# La Marzocco Technical Bulletin #141

## Updated Swift Grinder Electronic Board December 26, 2017

5.305.1            TRANSFORMER BOARD SWIFT VER3

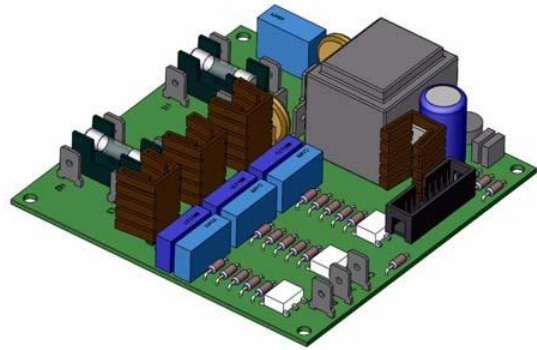
The Swift transformer board has been updated with new triacs. The new triacs can handle more cycles increasing the lifespan of the board. The part number has not changed and is as follows:

The updated Swift transformer board is backwards compatible with existing, current generation, button pads.
